# City of Alexandria, Virginia

## MEMORANDUM

**DATE:** JANUARY 17, 2024  
**TO:** MAYOR WILSON AND MEMBERS OF CITY COUNCIL  
**FROM:** KARL MORITZ, DIRECTOR; DEPARTMENT OF PLANNING & ZONING  
**SUBJECT:** DSUP #2023-10009, REZ #2023-00003, & MPA #2023-00002/301 North Fairfax Street

**BUILDING SETBACK EXHIBIT**  
**301 N FAIRFAX STREET**

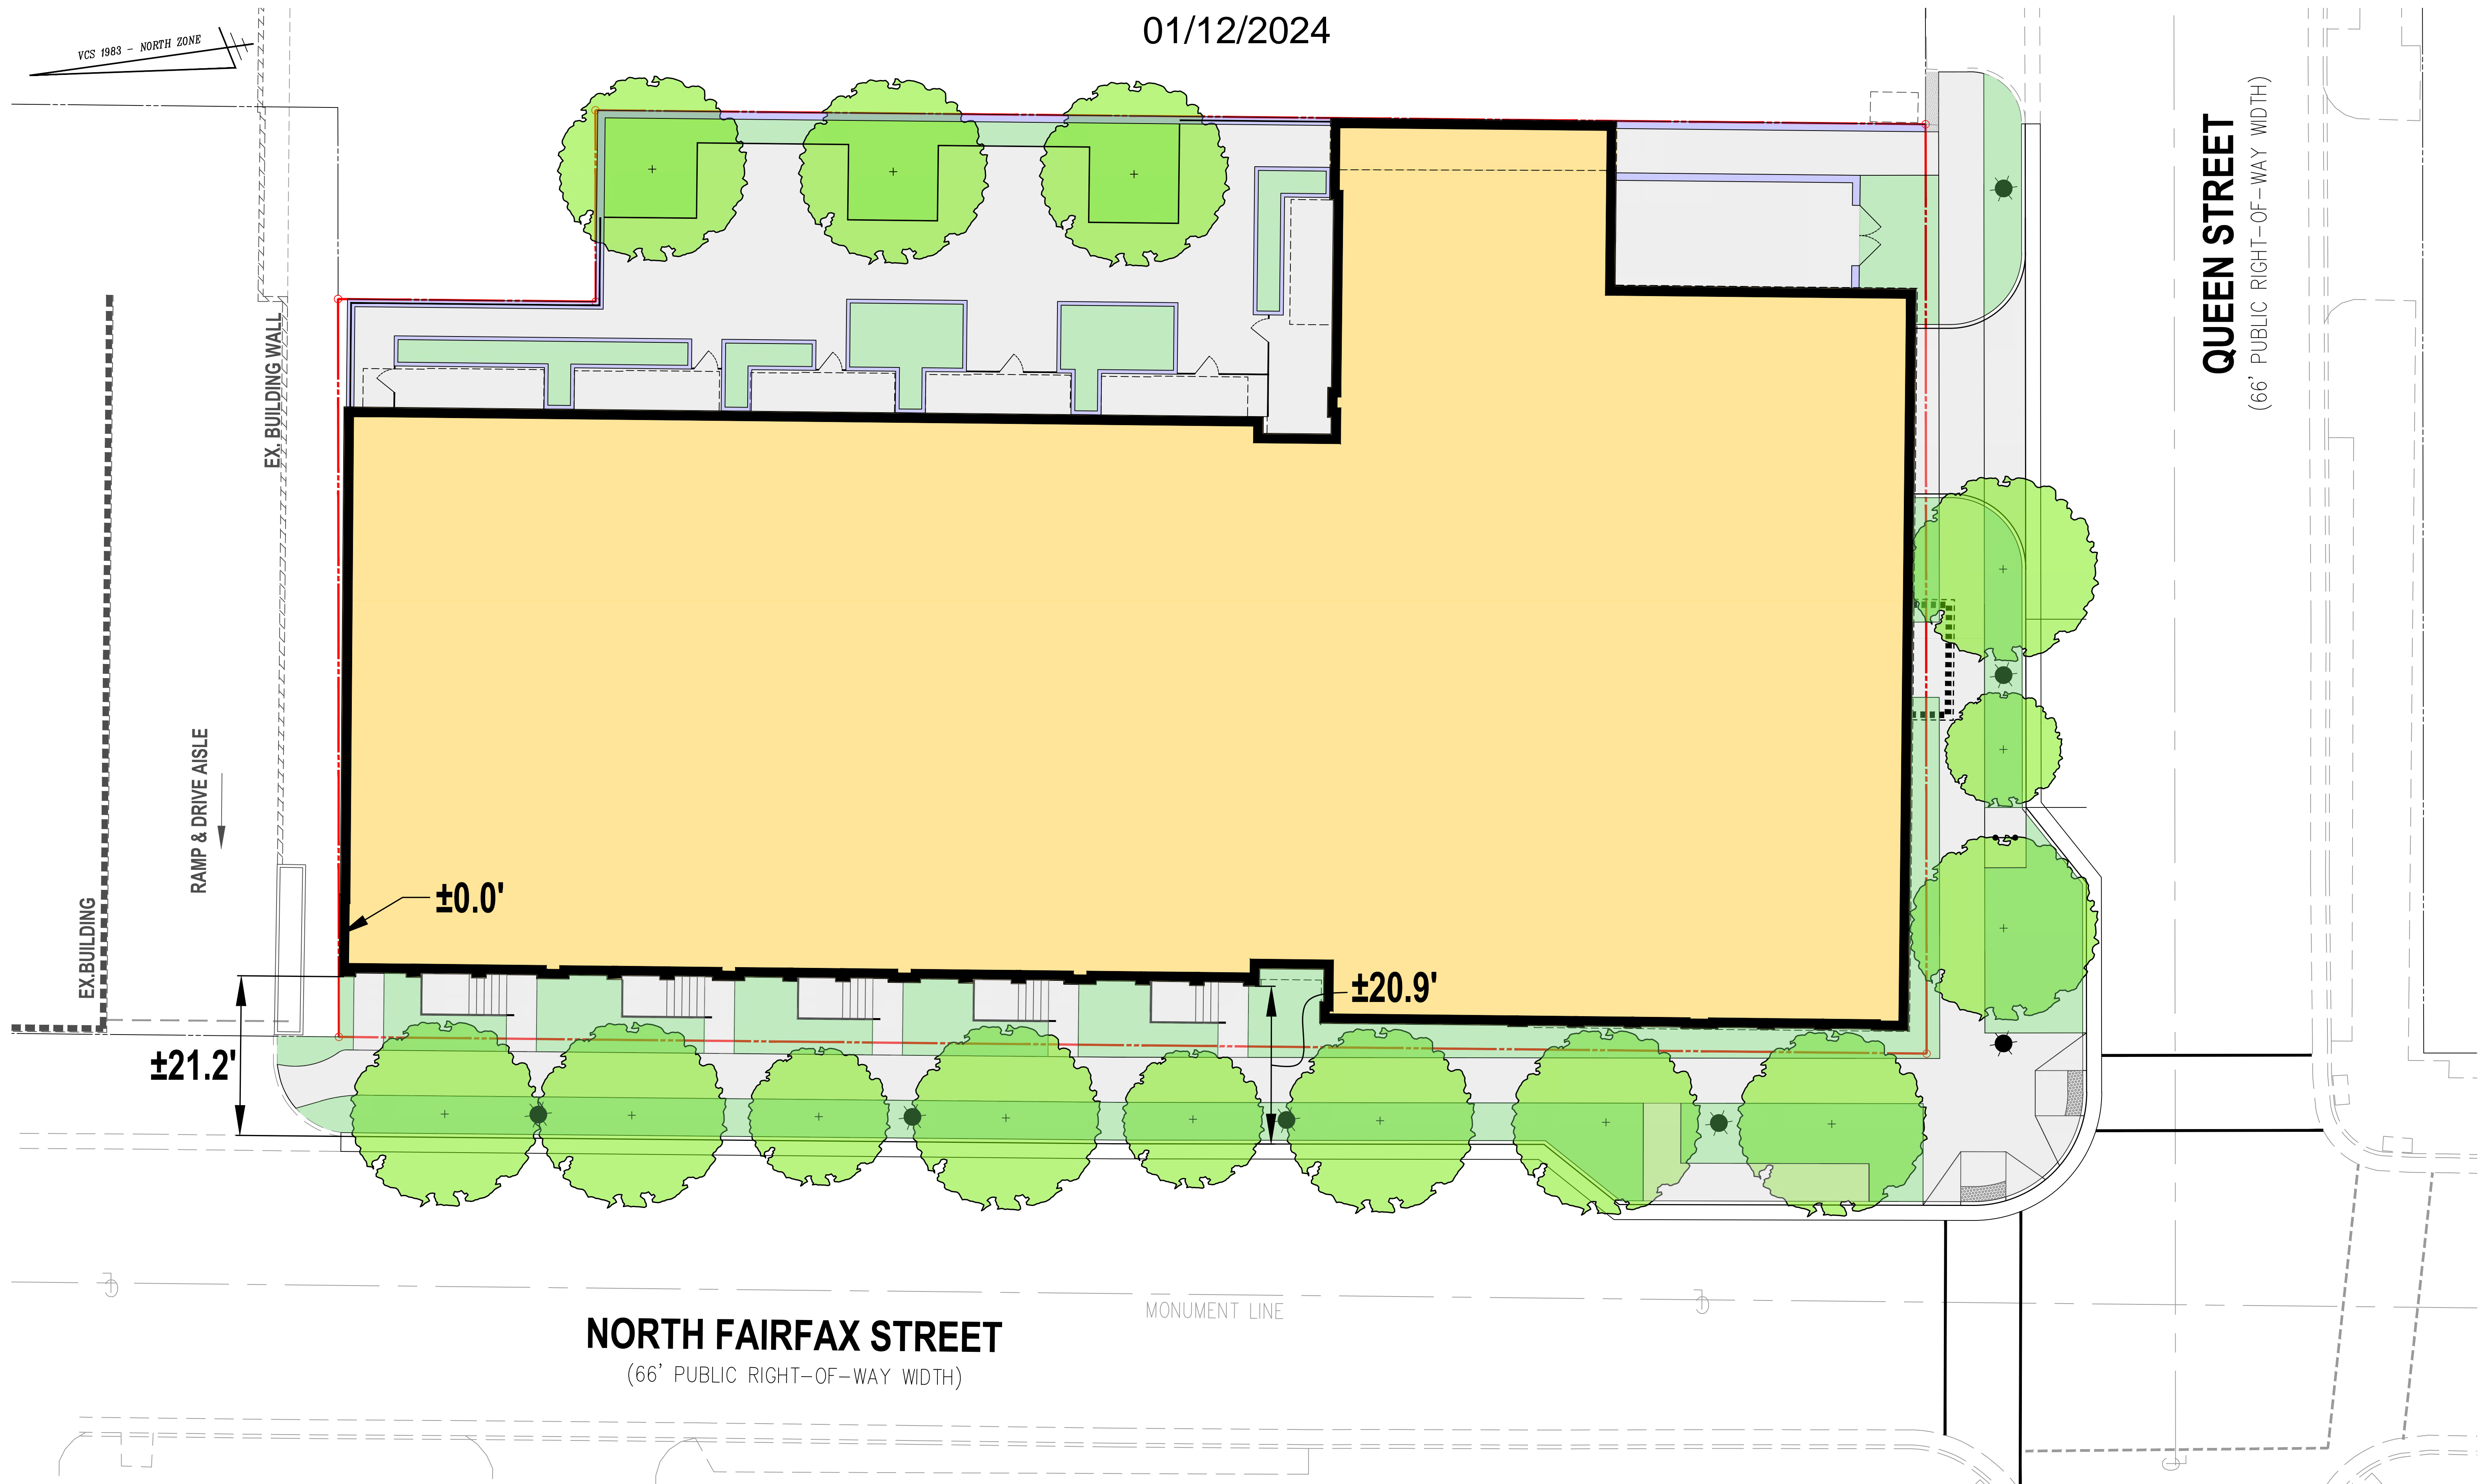
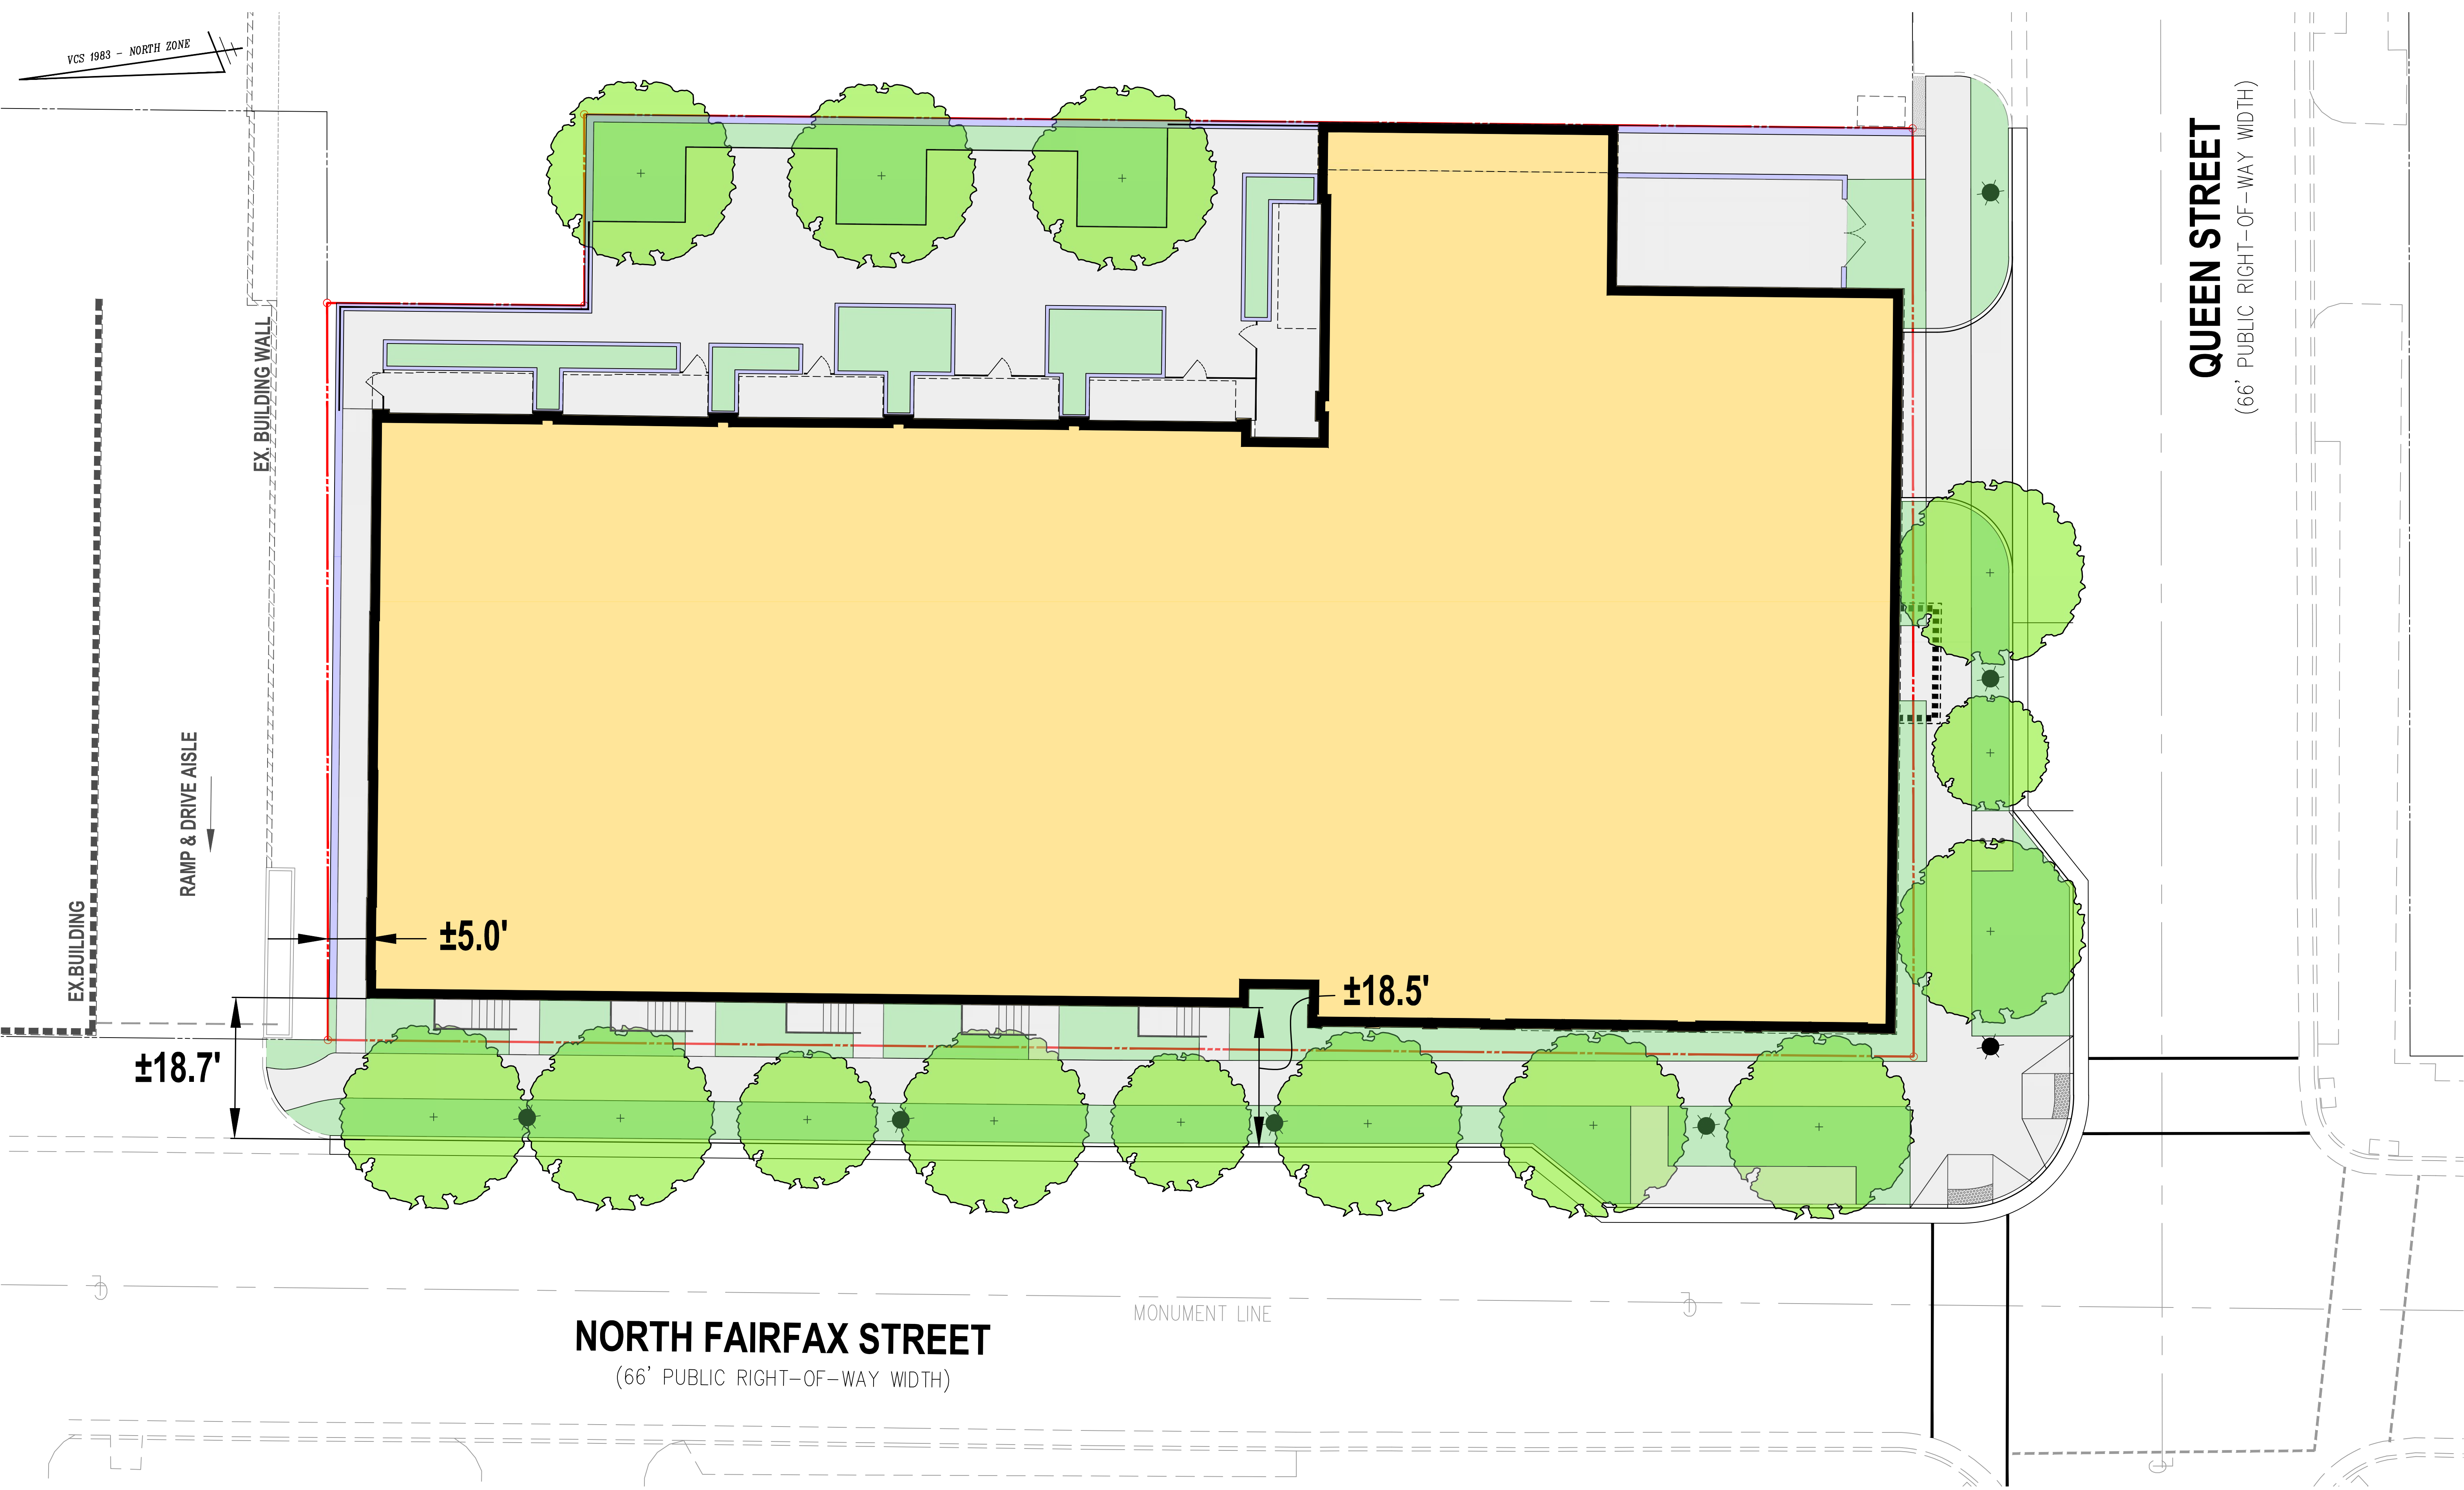
The attached *Exhibit A* shows changes to the building design proposed by the applicant in response to concerns raised about the lack of a building break through the block at the north property line as well as the blank walls proposed at both the north and east elevations. The building will be set back approximately 5 feet from the north property line to provide a physical and visual break through the site toward the river. The floor area will remain the same and be shifted along the North Fairfax Street elevation. The building will still have setbacks and entry stoops along North Fairfax Street. Due to the setback, windows will be added to the façade of the north elevation, transforming this portion of the building from what was previously a blank wall. The building also previously included a blank wall at the east elevation and the applicant has proposed additional architectural refinements to provide a more visually interesting design. Staff supports the proposed revisions to the building design and the setback and has proposed condition language below.

9. The building design, including the appearance, color, and quality of materials; final detailing; three-dimensional expression; and depth of all plane changes, shall be consistent with the elevations dated August 22, 2023 **as revised by Exhibit A, dated January 12, 2024, showing updated revisions to the north and east elevations and a setback from the north property line, and** the following conditions. Provide this information regarding materials and design to the satisfaction of the Director of P&Z prior to Final Site Plan release: (P&Z) (Code) \*
